Cannon Beach Planning Commission

Staff Report Addendum (10:00 AM February 24, 2022)

PUBLIC HEARING AND CONSIDERATION OF **AA 22-01**, GREG HATHAWAY'S, ON BEHALF OF JEFF AND JENNIFER HARRISON, APPEAL OF THE CITY'S ADMINISTRATIVE APPROVAL OF A BUILDING/DEVELOPMENT PERMIT FOR 534 NORTH LAUREL STREET. THE PROPERTY IS LOCATED AT 544 N. LAUREL STREET (TAX LOT 07002, MAP 51019AD), AND IN A RESIDENTIAL MEDIUM DENSITY (R2) ZONE. THE REQUEST WILL BE REVIEWED PURSUANT TO MUNICIPAL CODE, SECTION 17.88.180, REVIEW CONSISTING OF ADDITIONAL EVIDENCE OR DE NOVO REVIEW AND APPLICABLE SECTIONS OF THE ZONING ORDINANCE, CONDITIONS OF APPROVAL OF THE CANNON BEACH PRESERVATION PLANNED DEVELOPMENT SUBDIVISION AND APPROVED PLAT.

Prepared By: Jeffrey S. Adams, PhD

A2.1

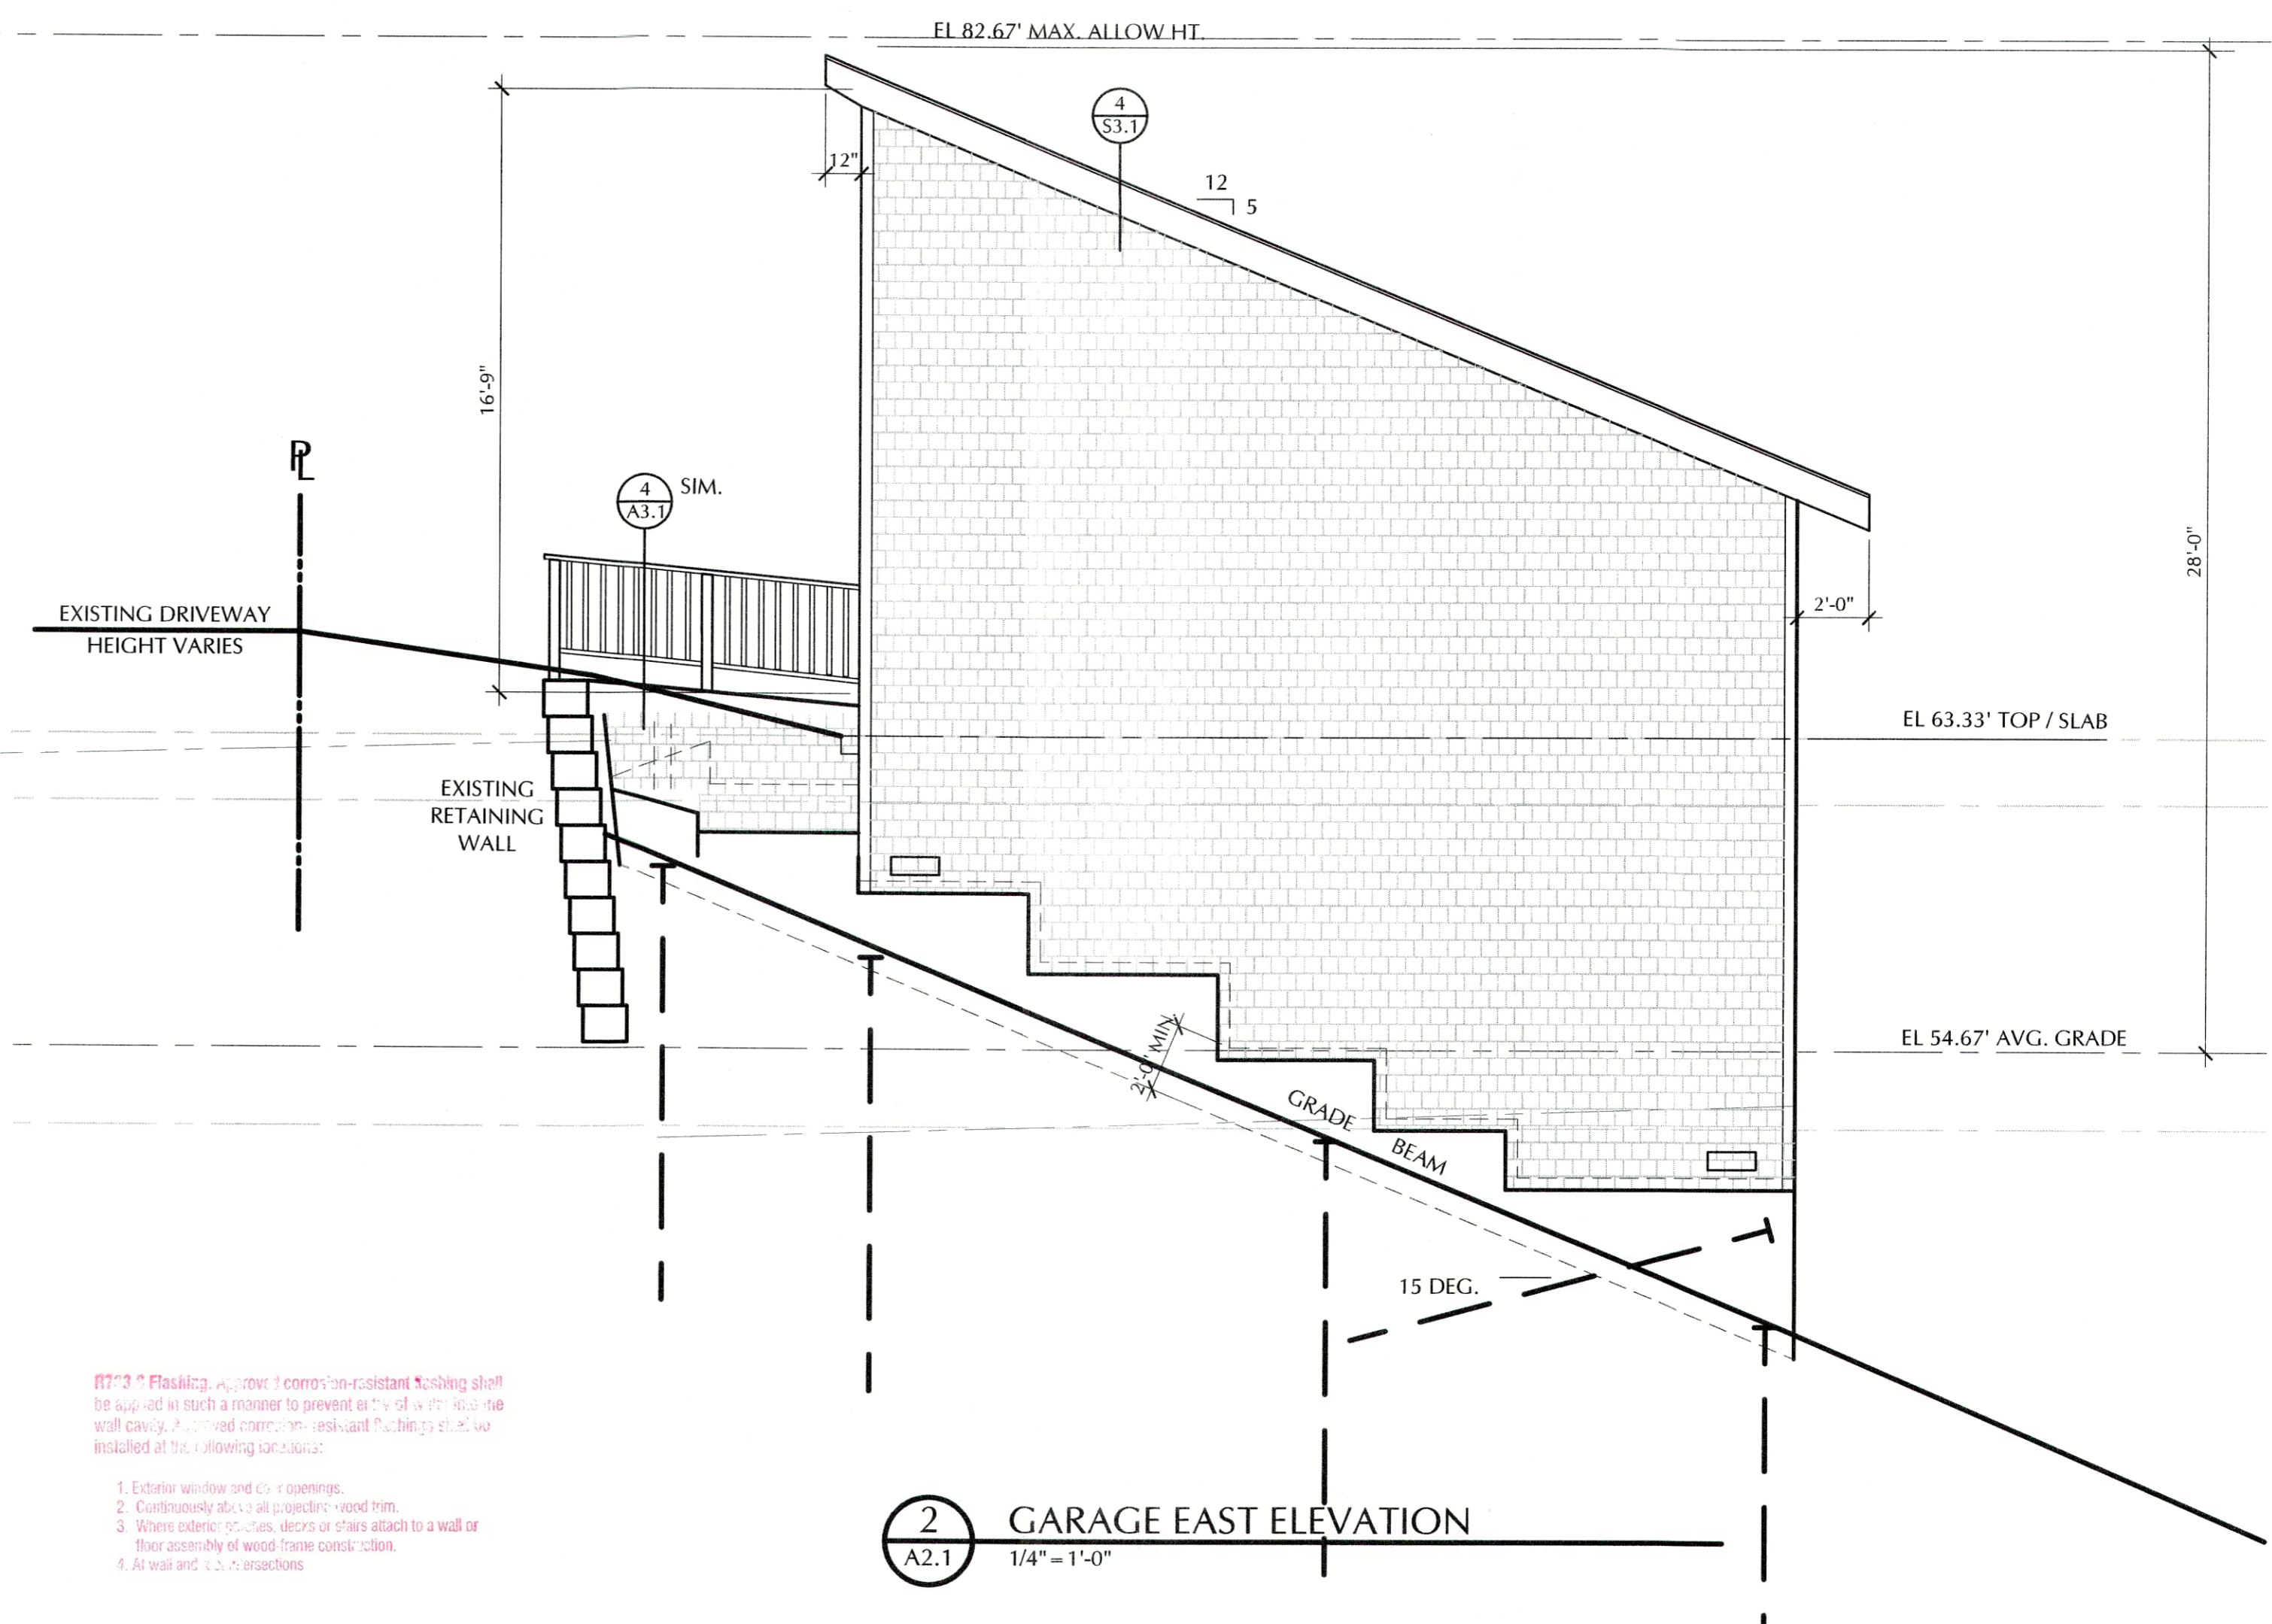
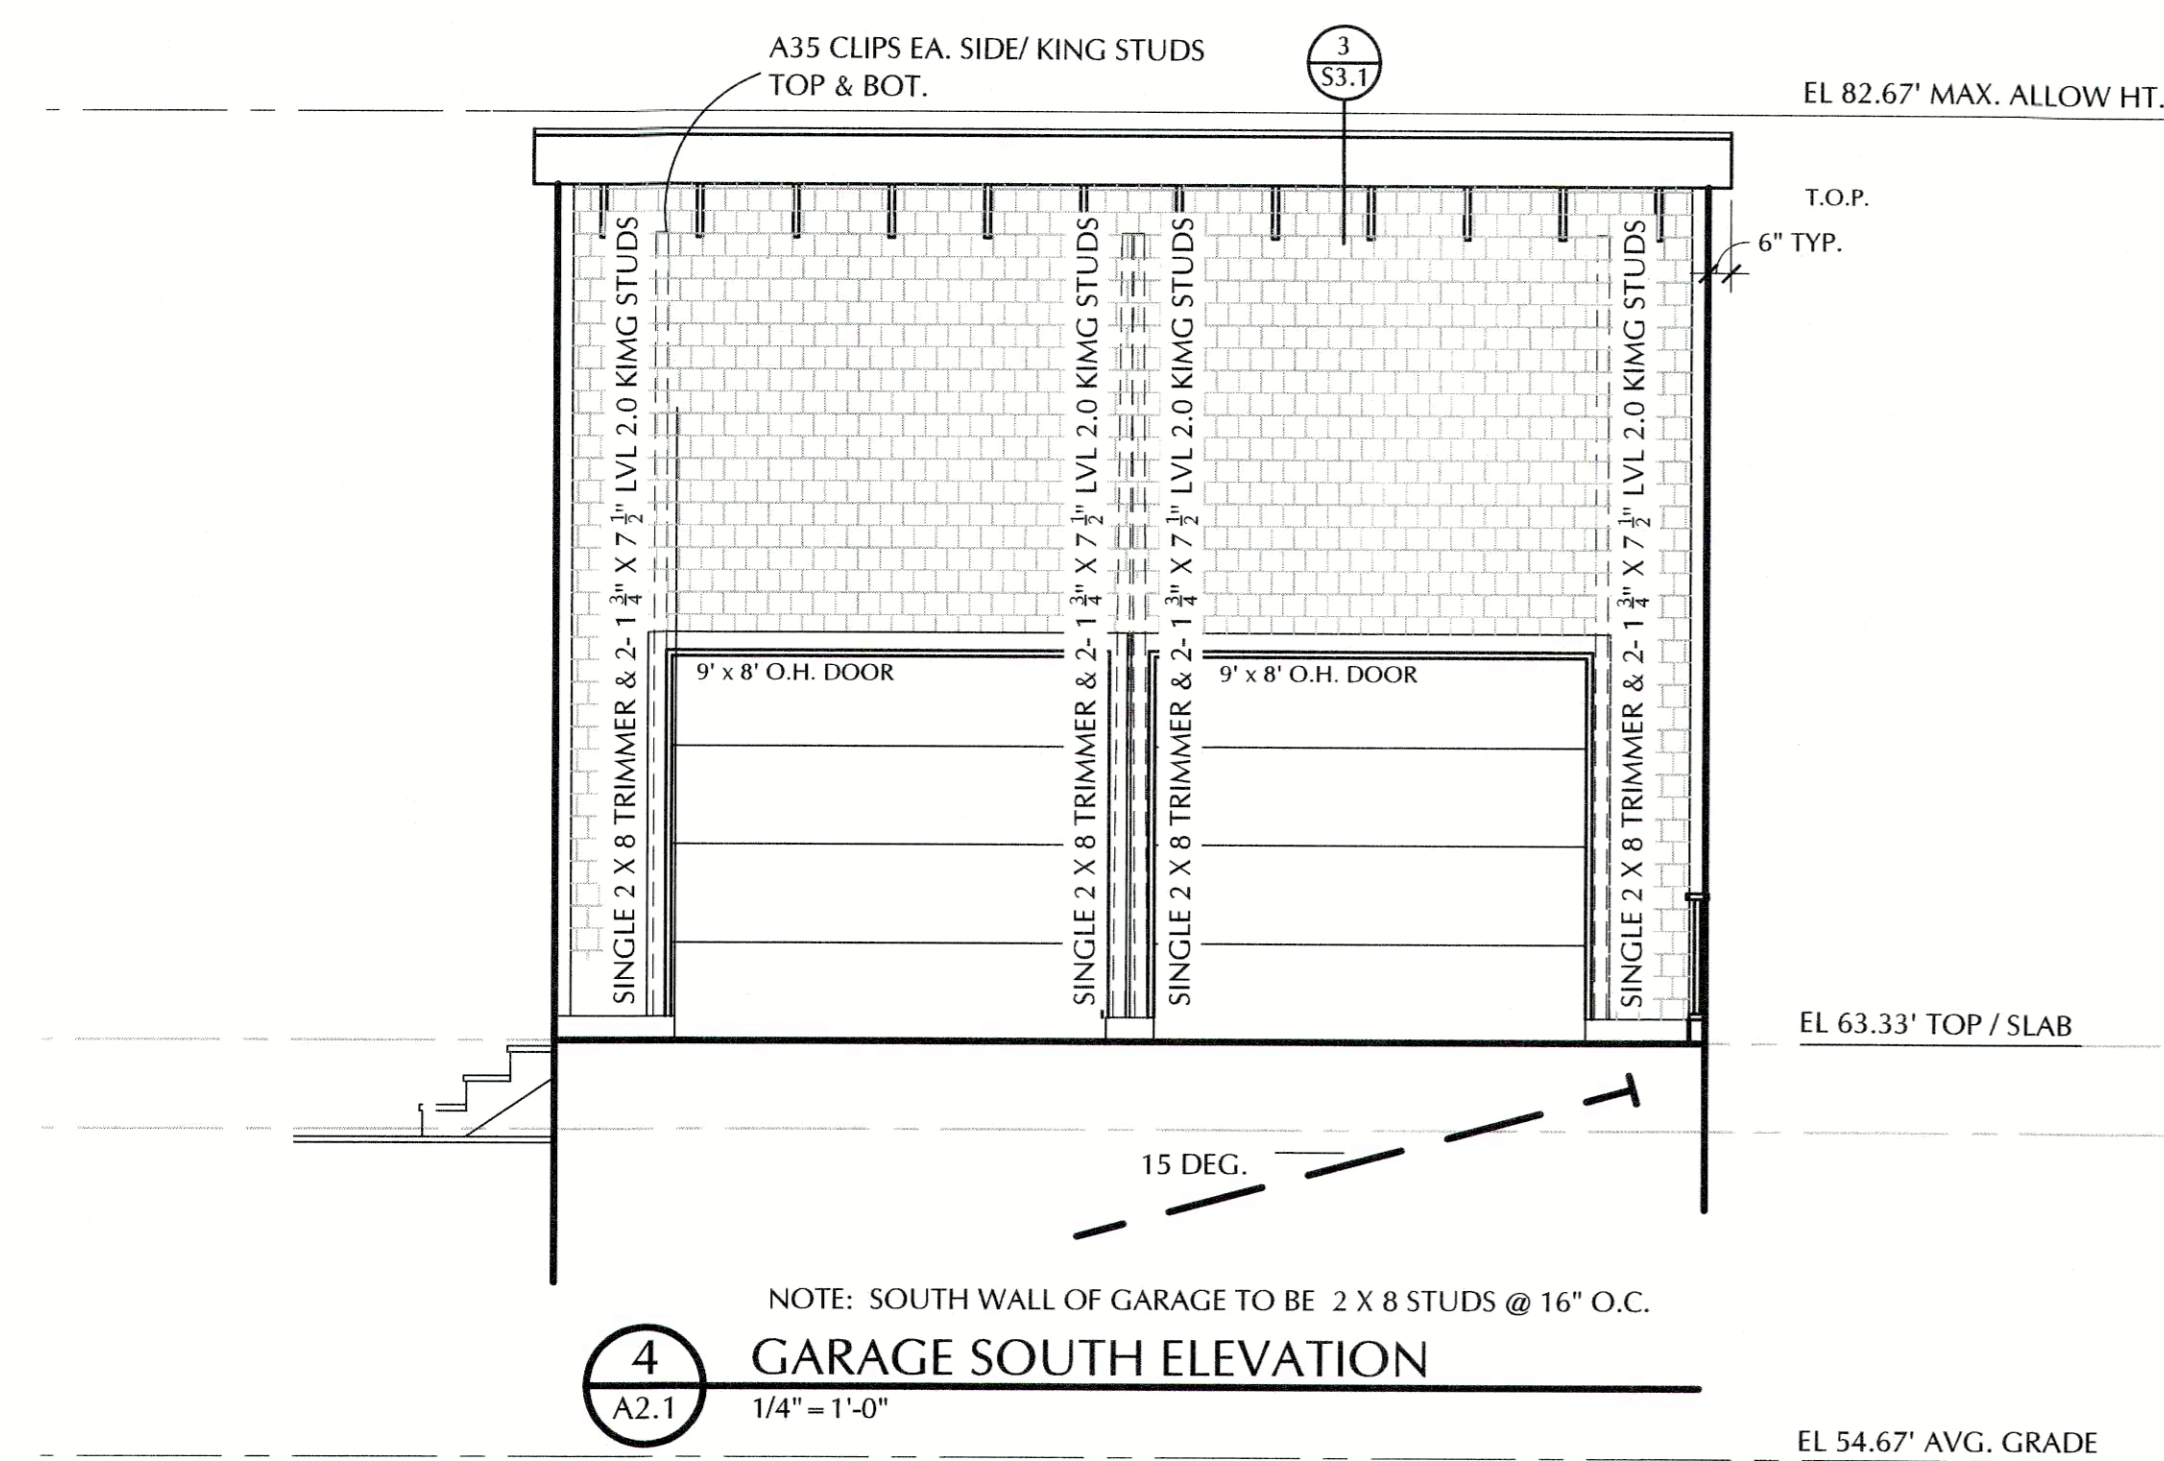
The submitted and approved building plans for the detached two-story garage show two distinct areas: (1) an upper space for parking two vehicles and (2) a lower space that is substantially above grade. In particular, the lower space:

Because the height of the lower area between the average grade and finished surface of the floor of the parking area above measures over 6 feet for more than 50% of the total area, and the finished floor of the parking area appears to measure more than 12 feet above the finished ground at the tallest point, the Planning Commission finds the lower area of the proposed detached garage qualifies as a story and a story above grade plane.

Because height of the lower area between the average grade and finished surface of the floor of the parking area above measures over 6 feet, and the finished floor of the parking area appears to measure more than 12 feet above the finished ground at the tallest point, the Planning Commission finds the lower area of the proposed detached garage qualifies as a story and story above grade plane. Therefore, the proposed garage is a detached 2-story garage and violates PUD Condition No. 16.

Therefore, the Planning Commission concludes that the issued Building Permit violates PUD Condition No. 16 since the proposed detached garage is a two-story garage.

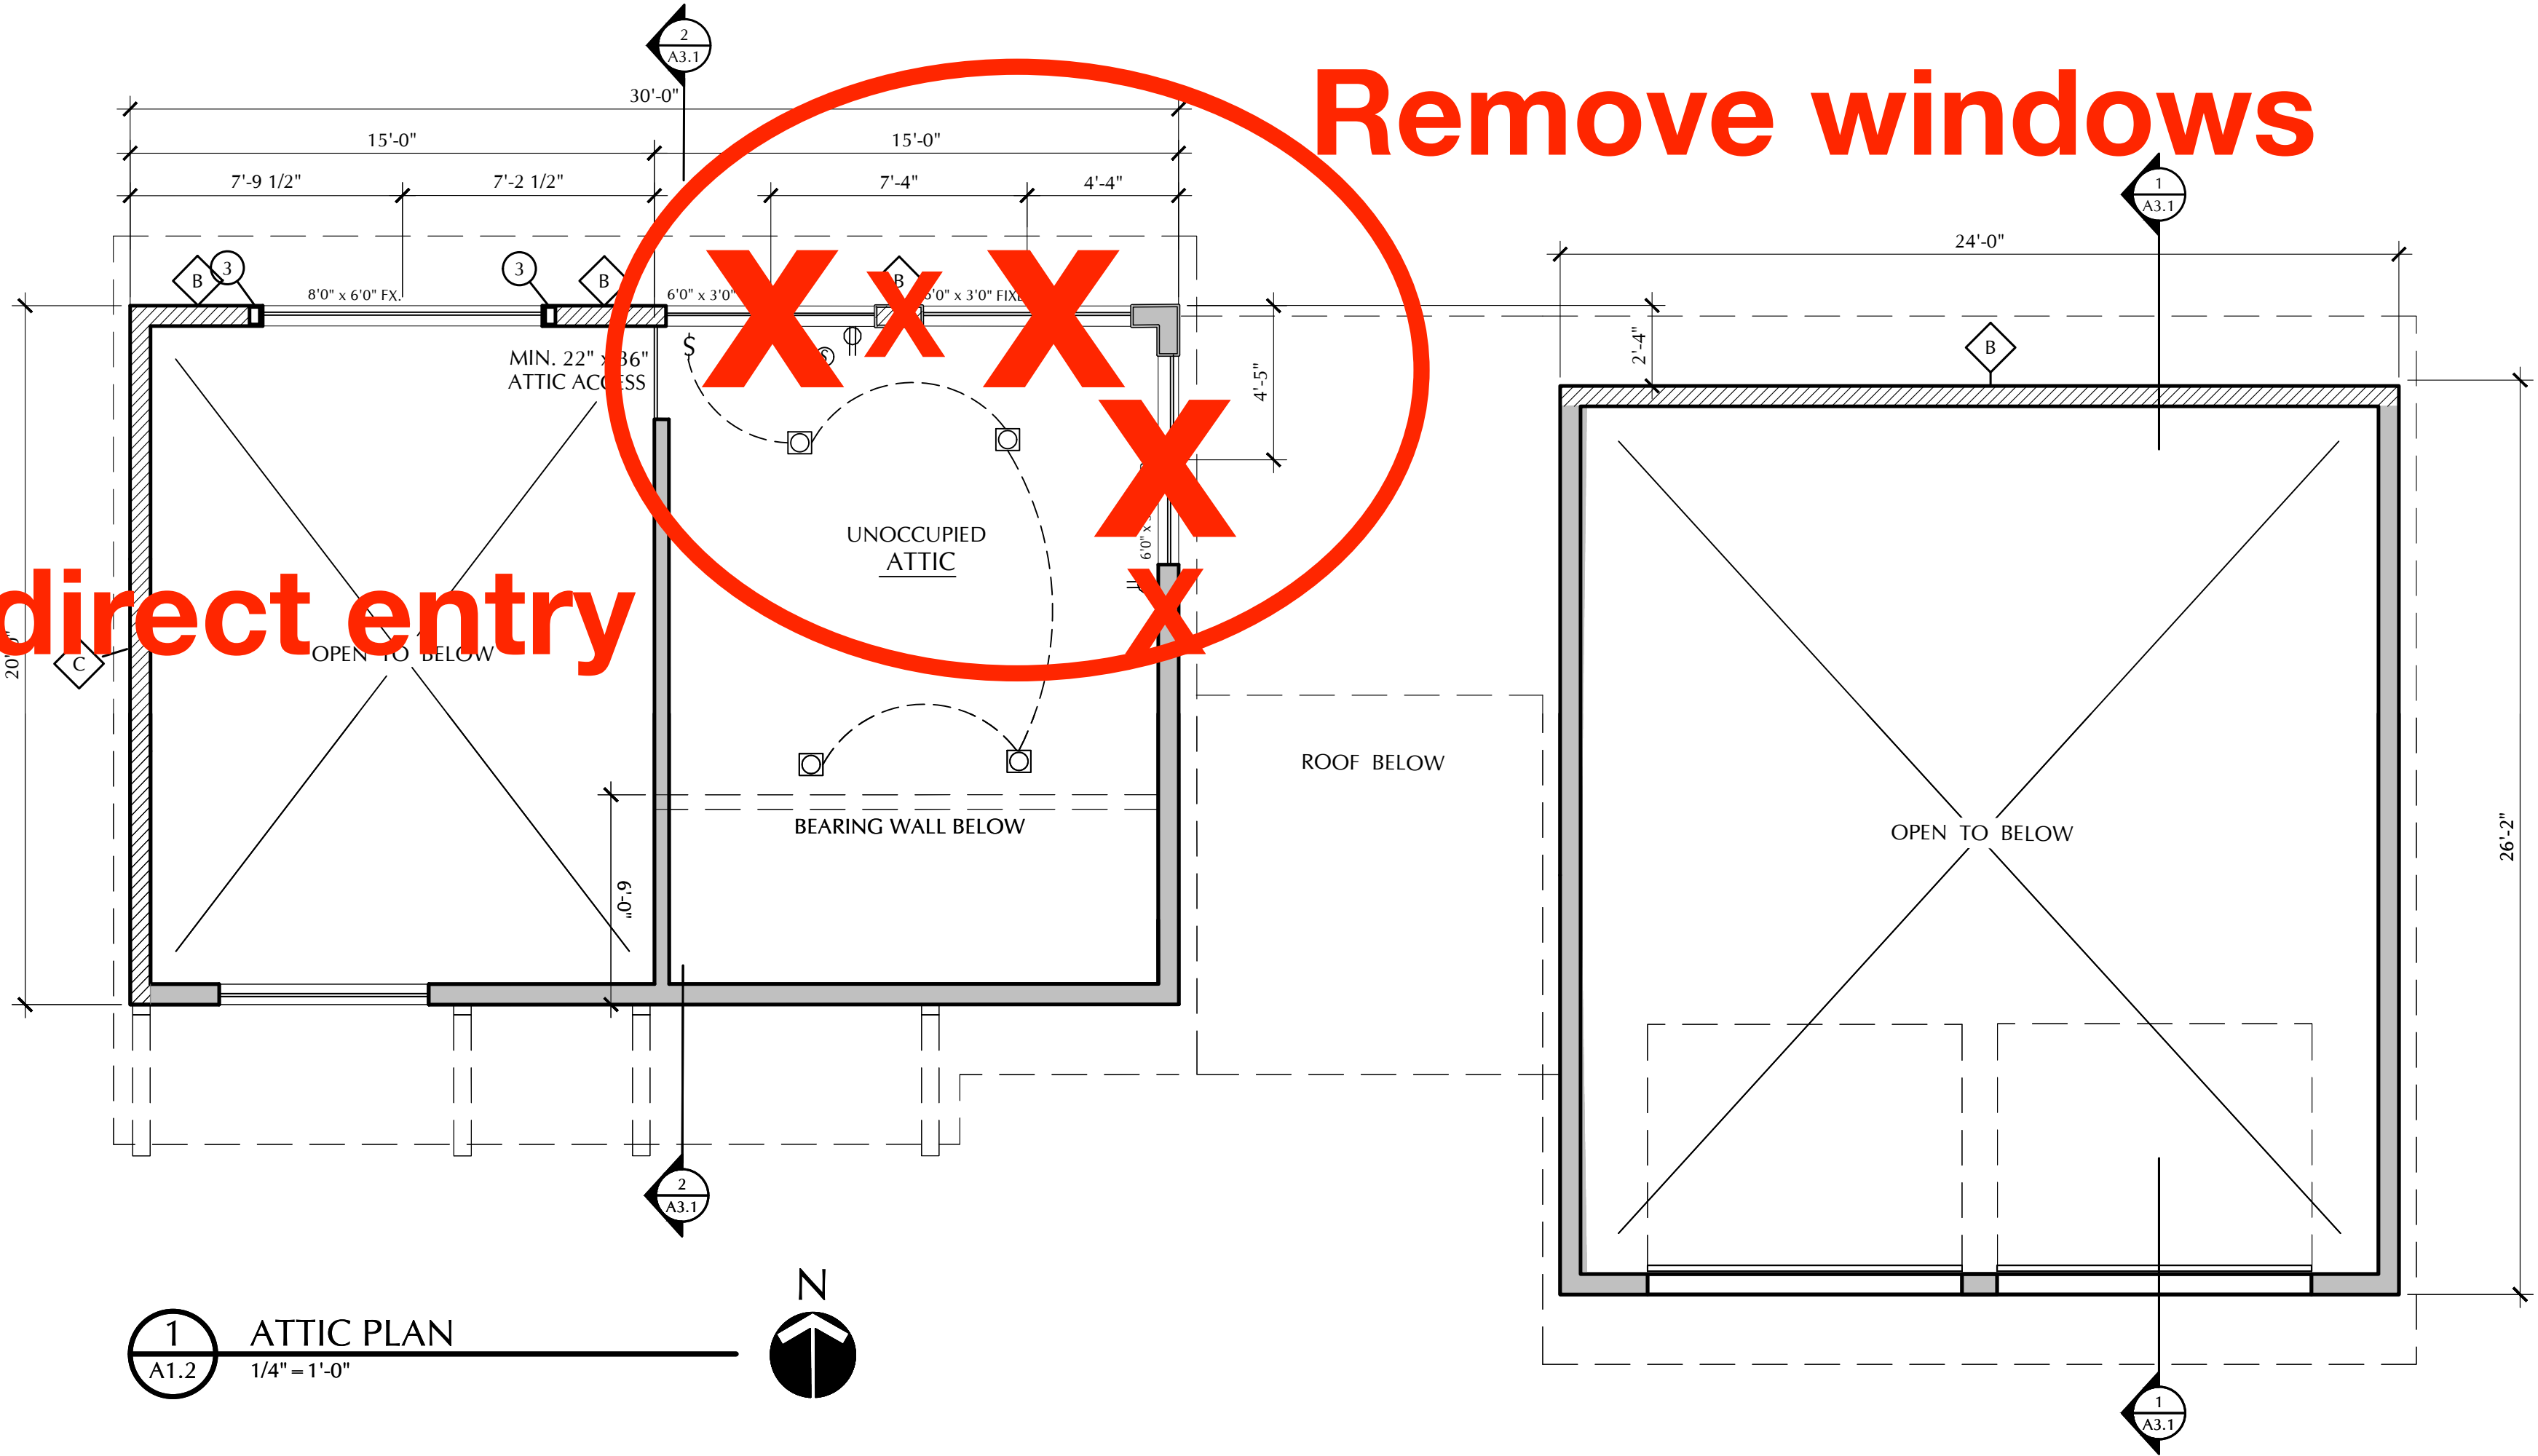
Remove electrical outlets
